# MONTGOMERY COUNTY HISTORIC PRESERVATION COMMISSION STAFF REPORT

Address: 101 Elm Ave., Takoma Park Meeting Date: 12/20/2023

Case Number: 1051115 Staff: Dan Bruechert

**Proposal:** Solar Panel Installation

Figure 2: The proposed arrangement of the solar panels.

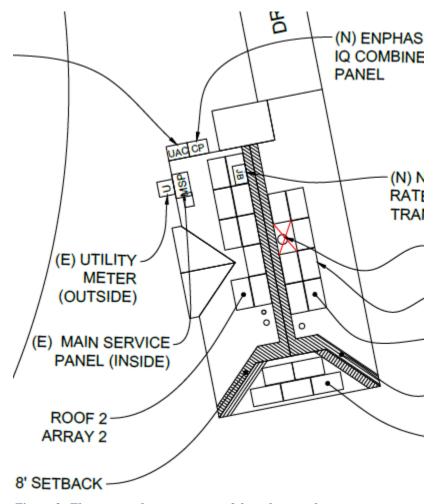
The subject property is a one-story Craftsman with a front gable roof with hip at the rear. The applicant proposes to install a total of 21 (twenty-one) solar panels on the roof, with seven on the east (left) roof slope, eight on the west (right) roof slope, and five on the non-historic rear addition (see below).

The HPC's adopted policy for roof-mounted solar panels directs Staff on how to evaluate proposed solar arrays. The first consideration is to consider the identified preferred locations which are, a free-standing array, detached accessory structure, rear elevation, and on non-historic additions. The subject property does not have enough open land to accommodate a free-standing array and the detached garage is too obscured by mature trees to receive adequate direct sunlight. There is a small rear hipped roof, and the applicant is utilizing it with five panels. Staff finds the applicant is utilizing the preferred locations to the greatest extent possible.

Second, Staff finds the roof neither architecturally nor materially significant. The front gable roof covered in three-tab shingles is common in the Takoma Park Historic District and, should the applicant wish, the roof could be returned to its historic configuration without impairing its integrity, per Standard 10.

Figure 3: The subject property (shown with a star) and adjacent Outstanding resources (shown with a plus symbol).

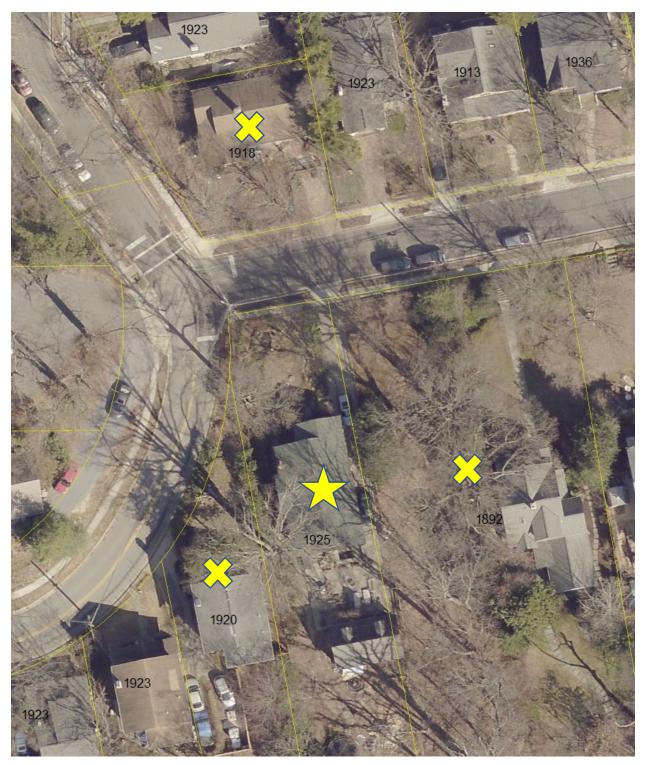
An additional consideration is the number of Outstanding resources in the vicinity of the subject property and how their view will be impacted by the proposed solar installation. The map, shown below, identifies three Outstanding Resources adjacent to the subject property, including 99 Elm Ave., 111 Elm Ave., and 30 Pine Ave. While there are Outstanding Resources adjacent to the subject property, Staff does not find that the proposed array will have a substantial impact on the character of the surrounding block.

SHEET NAME **ELEVATION** SHEET NO. A005

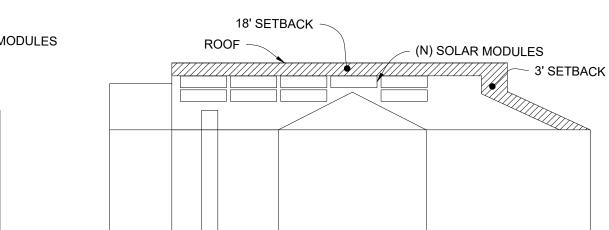
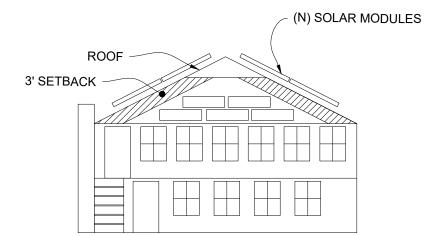
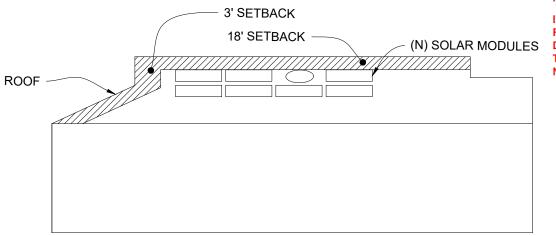
1) The drawings shall be revised to show the final height of the panels when they are installed on the racks. The height shall be no greater than 6".
